Project No. 2021\_154

MIDLOTHIAN ISD STADIUM ADDITIONS AND RENOVATIONS

ADDENDUM NO. 2

DATE: October 18, 2021

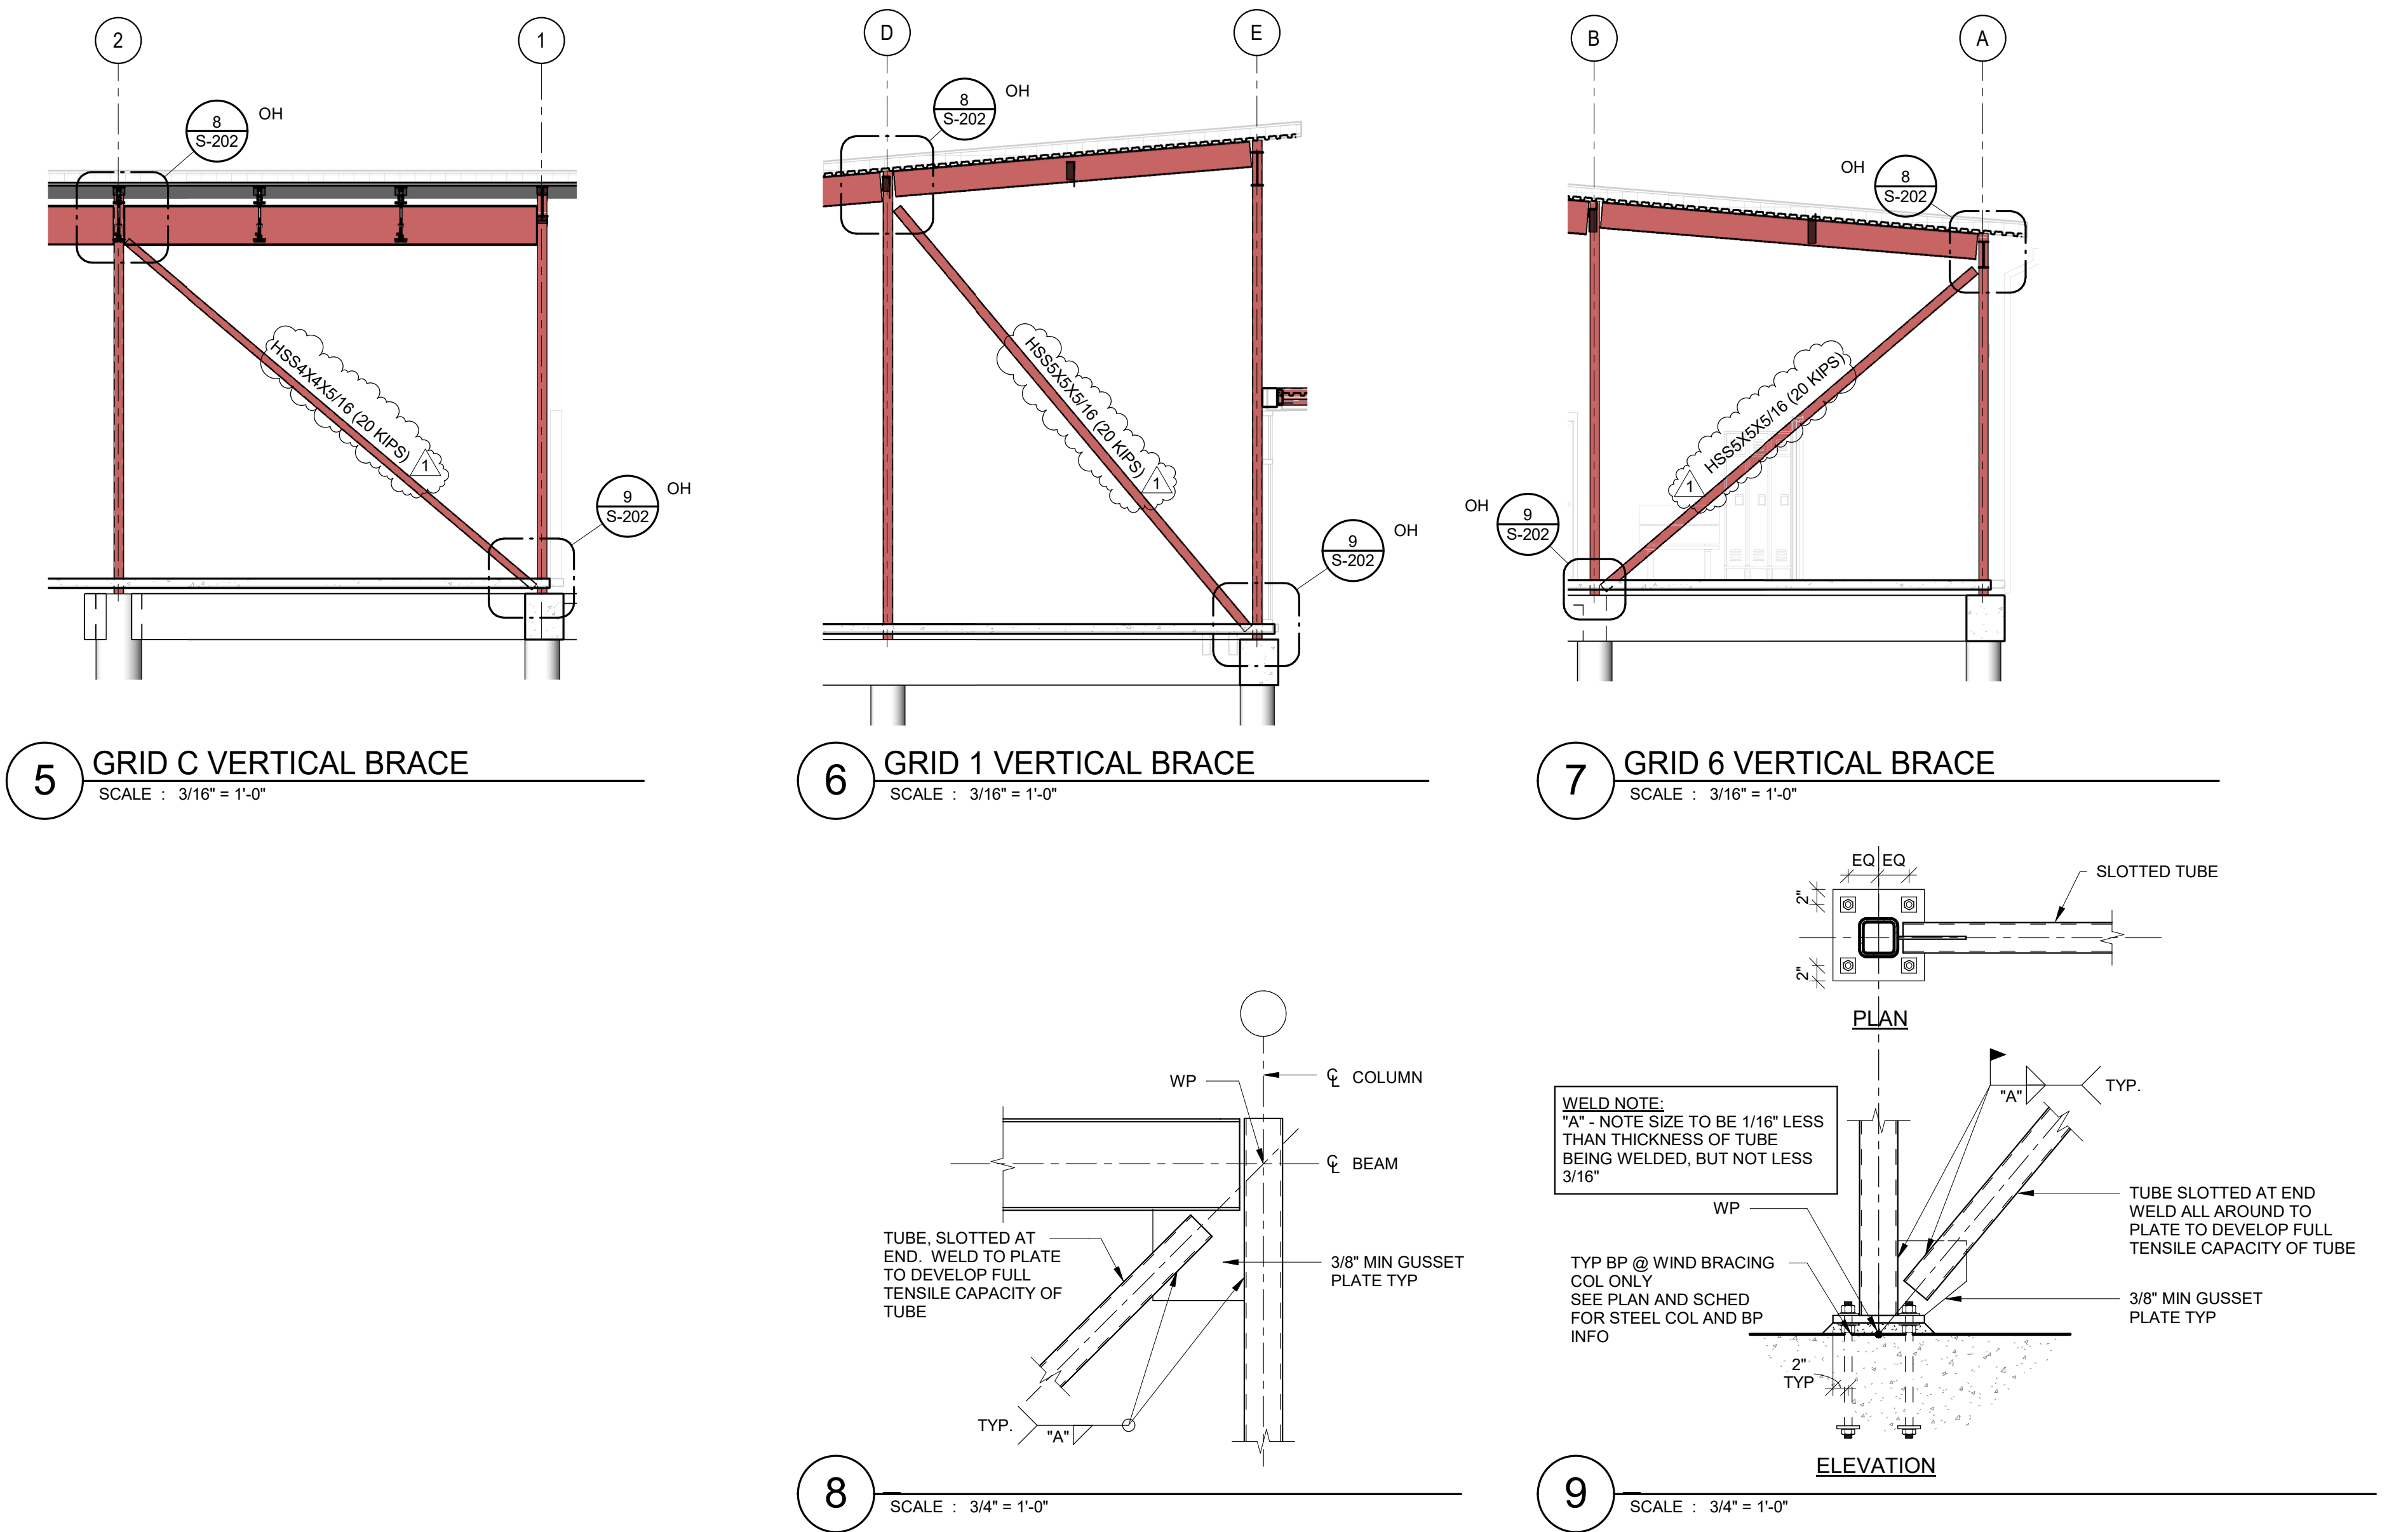
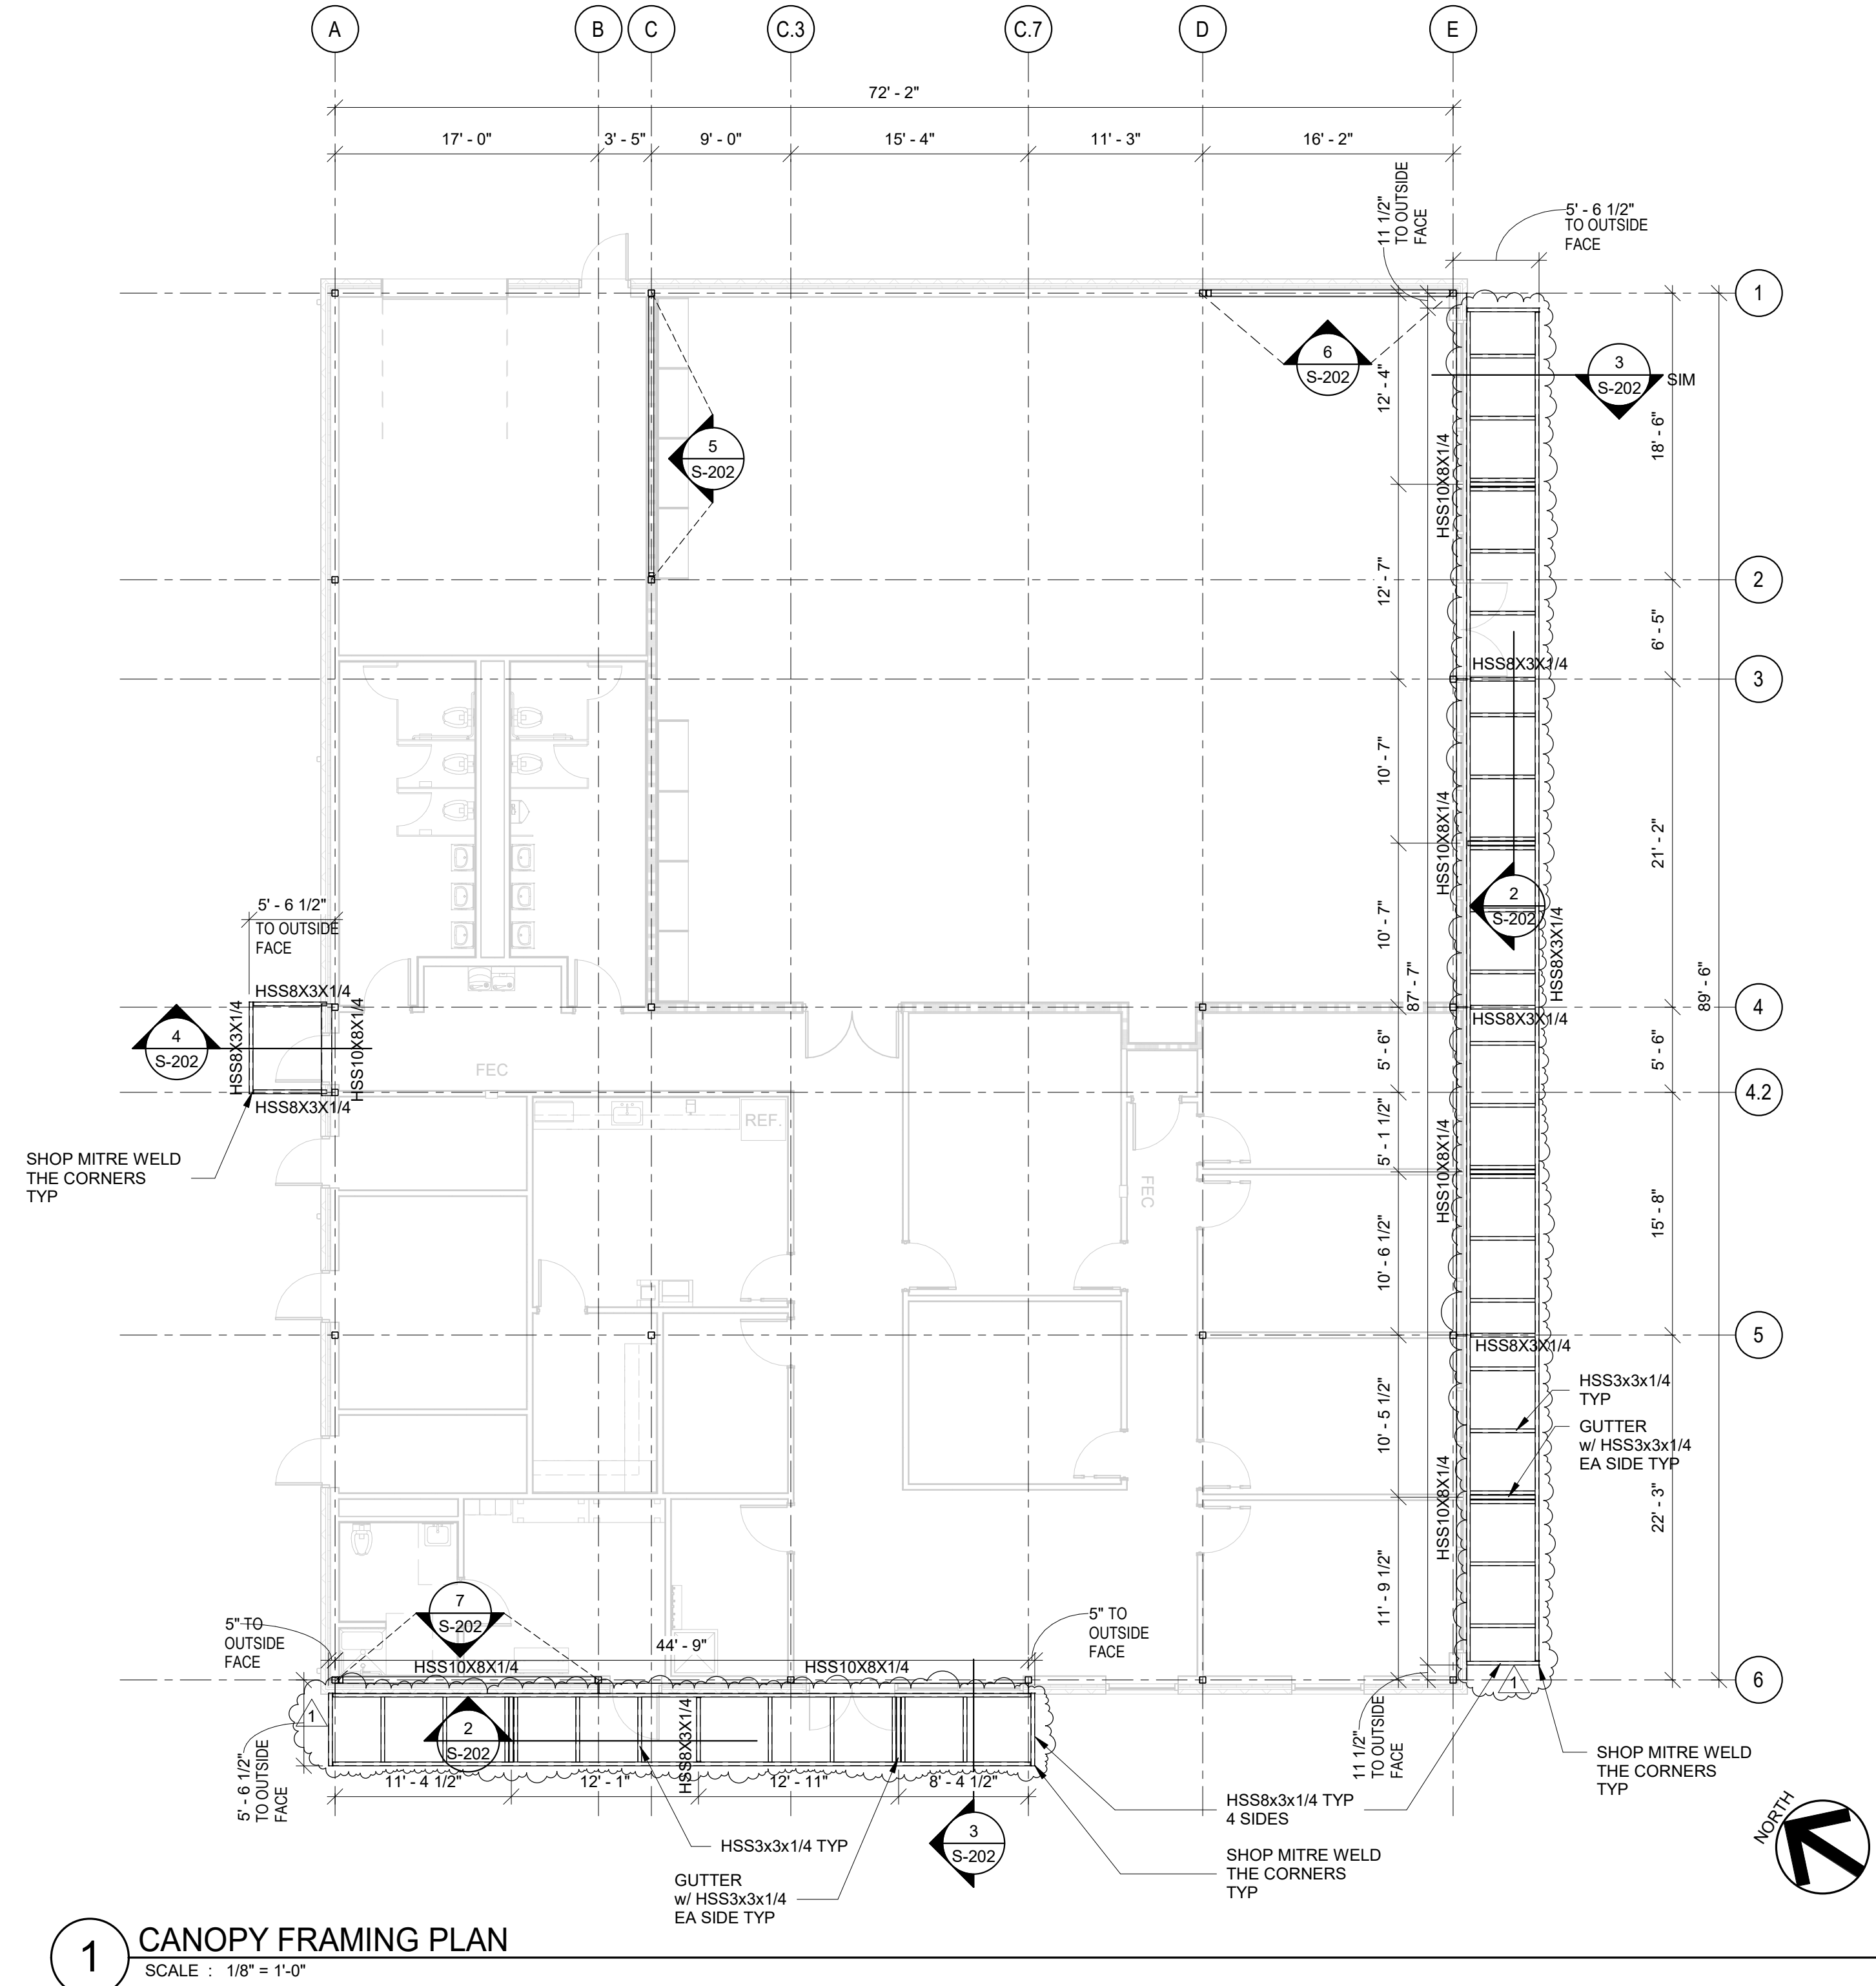
- a. 1/ S-202 Graphics UPDATED
- b. 3/ S-202 Text note ADDED for deck slope
- c. 5,6,7/ S-202 Vertical Brace Forces UPDATED

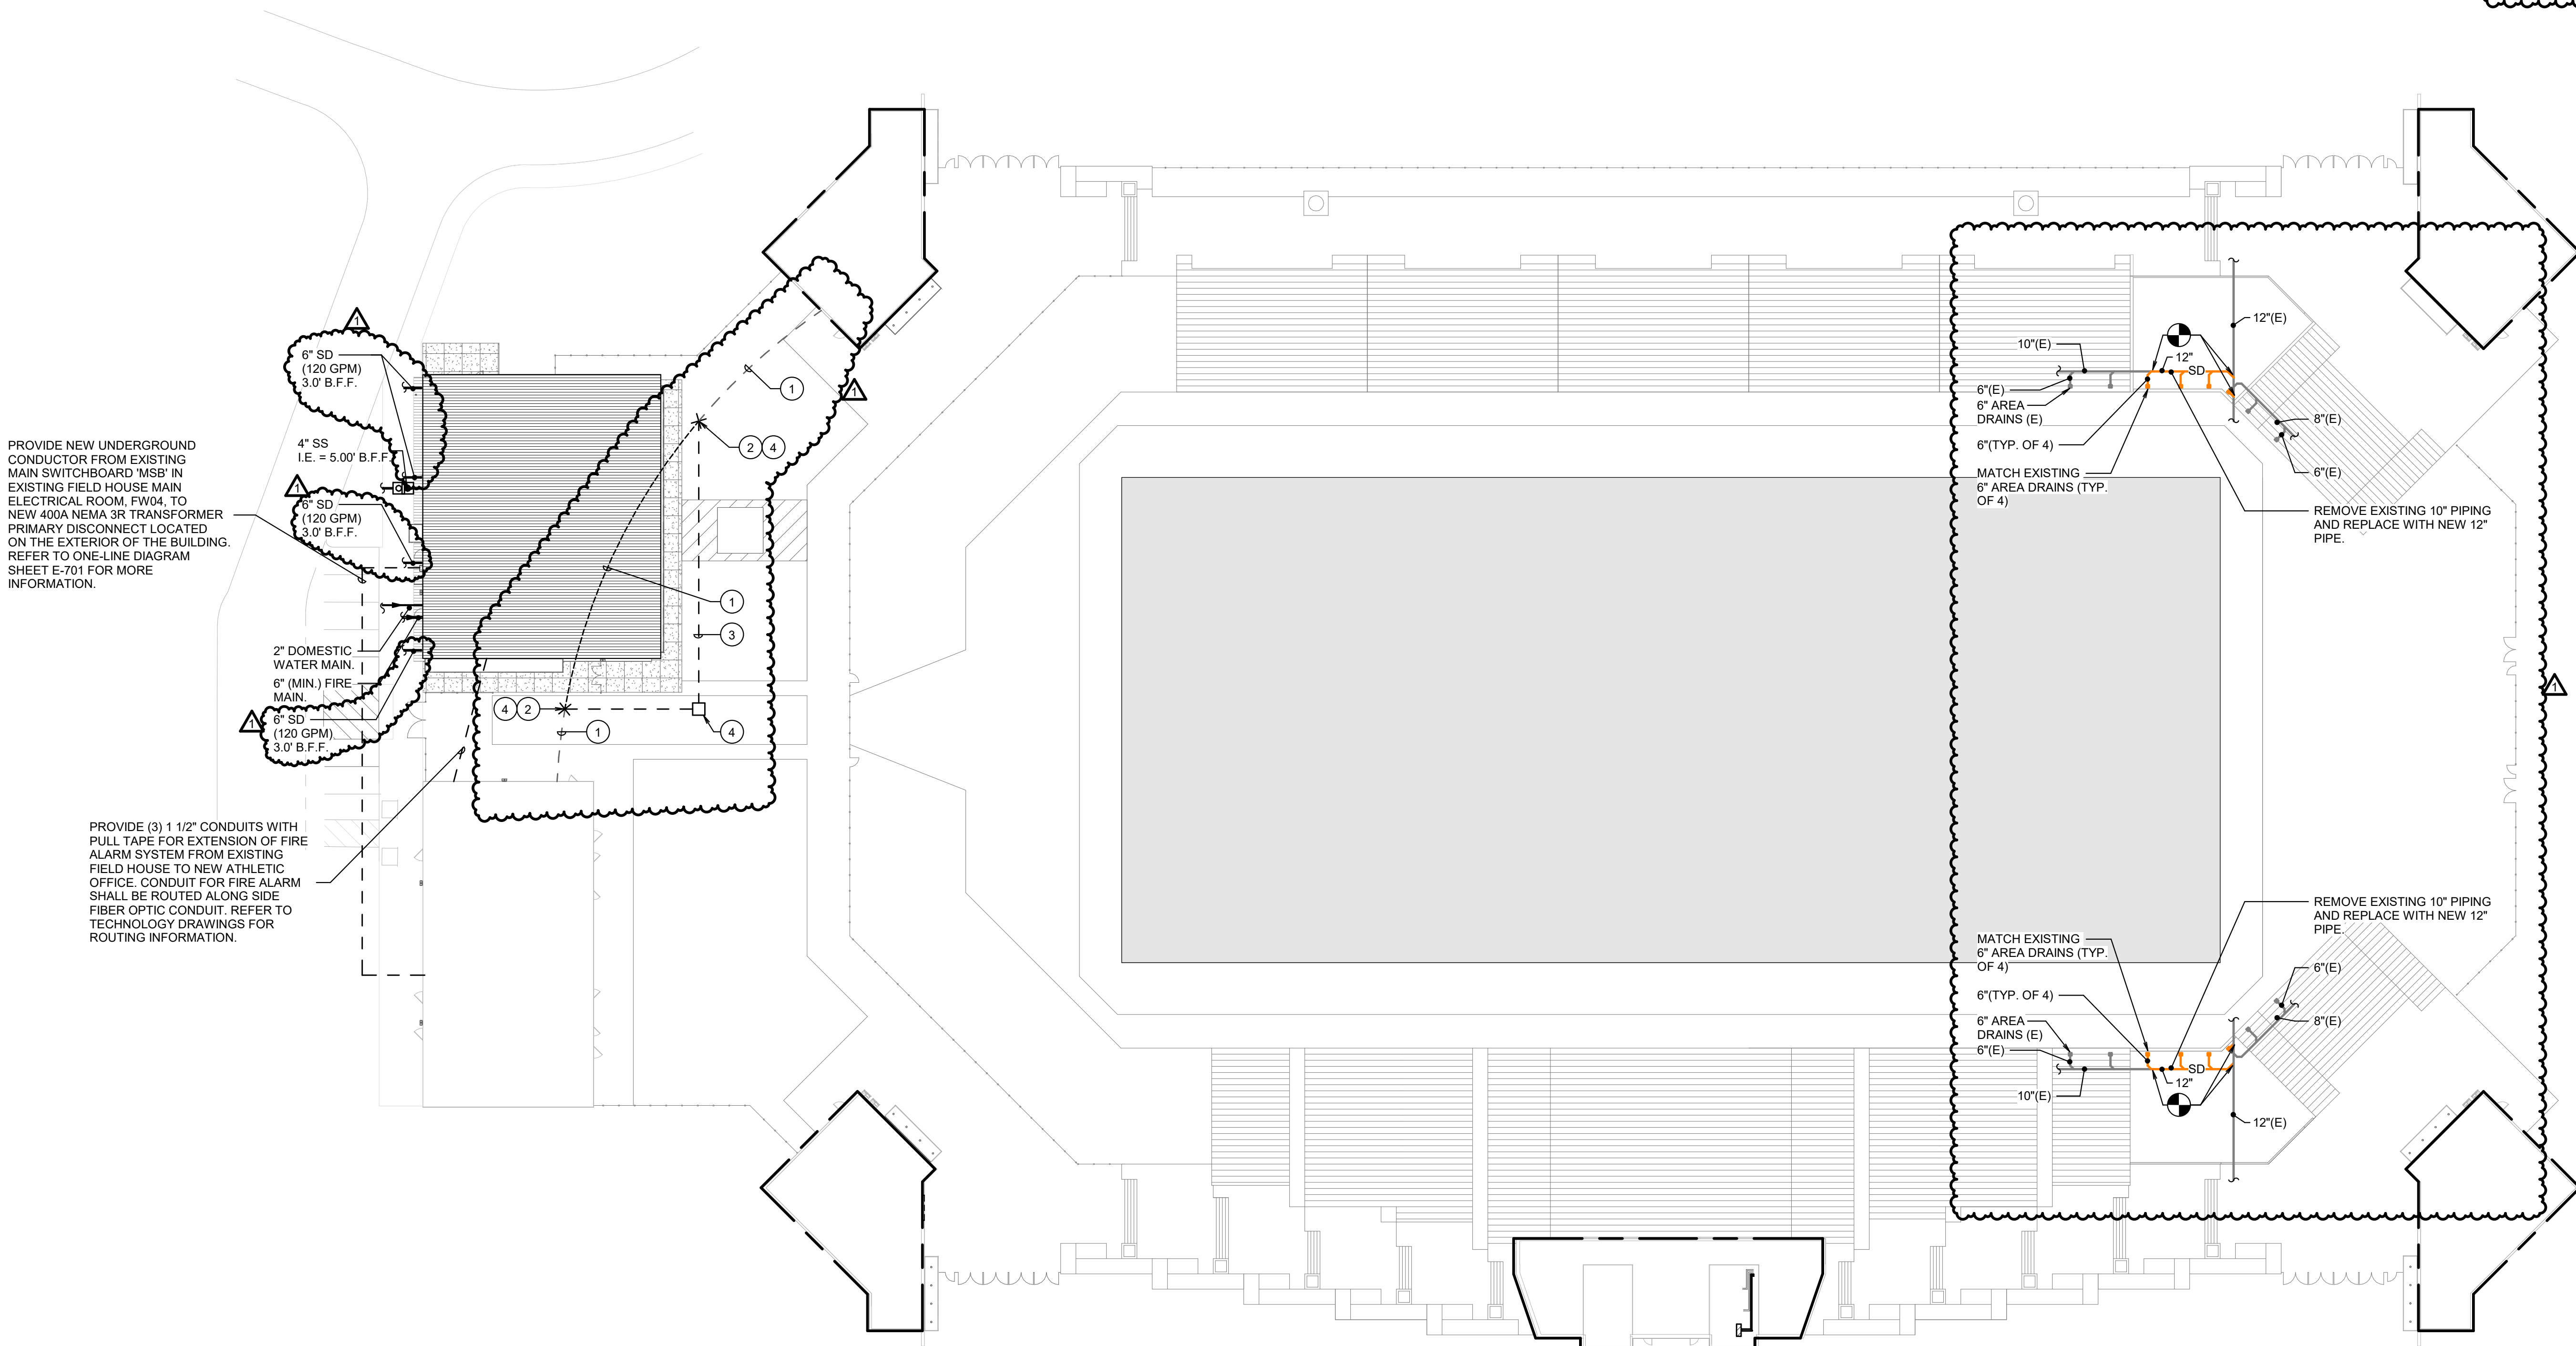
- A2.26 SHEET MPE-102 – SITE PLAN – MPE:  
REMOVE and REPLACE in its entirety.
- a. Refer to attached drawing storm drain REVISIONS at stadium seating and Athletic Office.

- b. Refer to attached drawing for RELOCATION of existing electrical feeder to concession building which conflicted with new athletic office building footprint.
